1968 Corvette: Service News: Corvette Folding Top Compartment Lid to Folding Top Interference (SN-68-20)

Source: Chevrolet Service News

Date: April 1968, Volume 40, Issue Number 4

Fig. 12—Remove 1/8" From Lid Stops

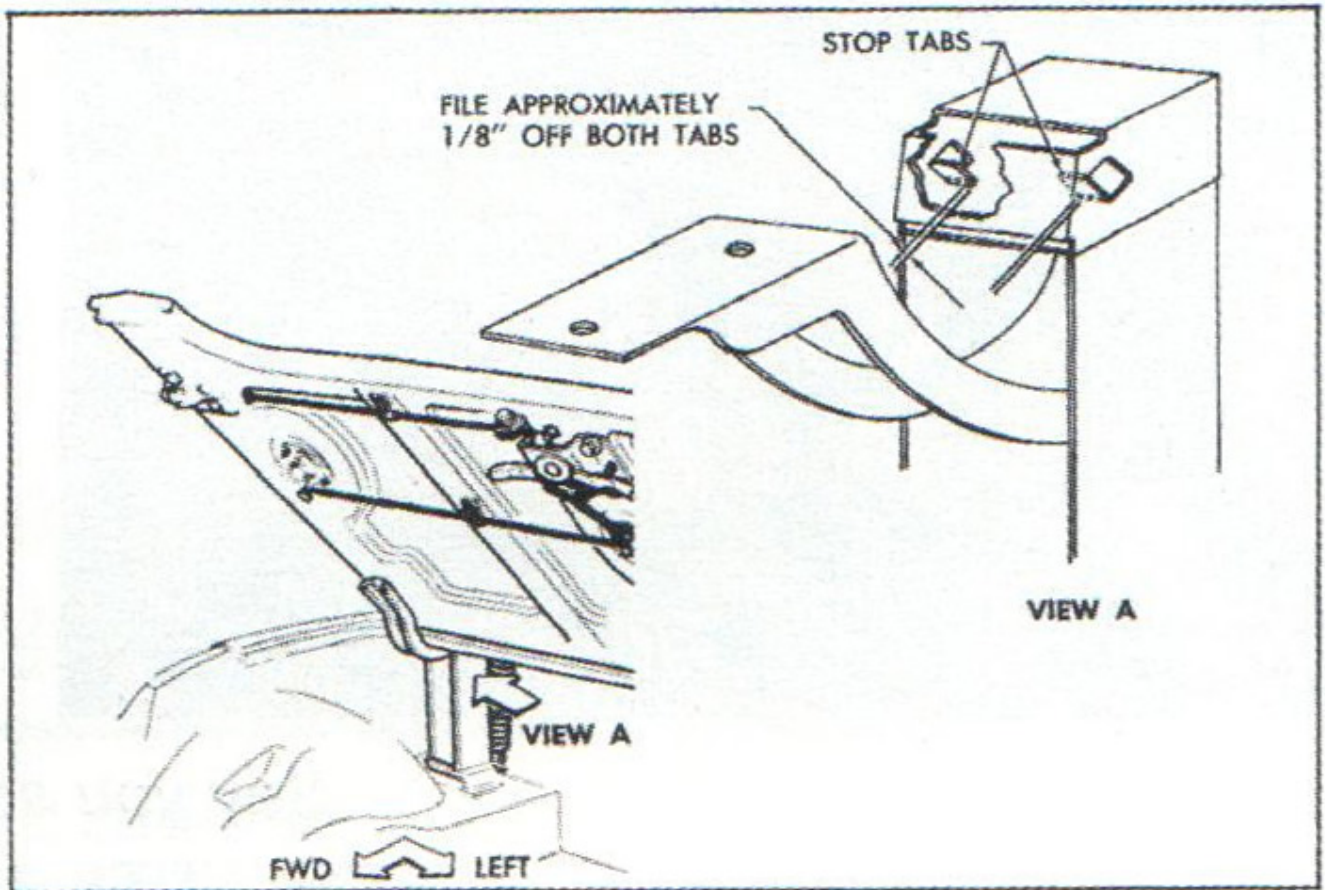
It has been found that the rear compartment lid on some 1968 Corvettes interferes with the convertible top when the top is being raised or lowered. This interference is easily eliminated by filing approximately 1/8" off the existing hinge stops (right and left side). Removing 1/8" from the hinge stops, as shown in Figure 12, allows the rear compartment lid to raise farther thus eliminating the interference condition. The stops referred to are simply tabs that has been punched out of the hinge support members.
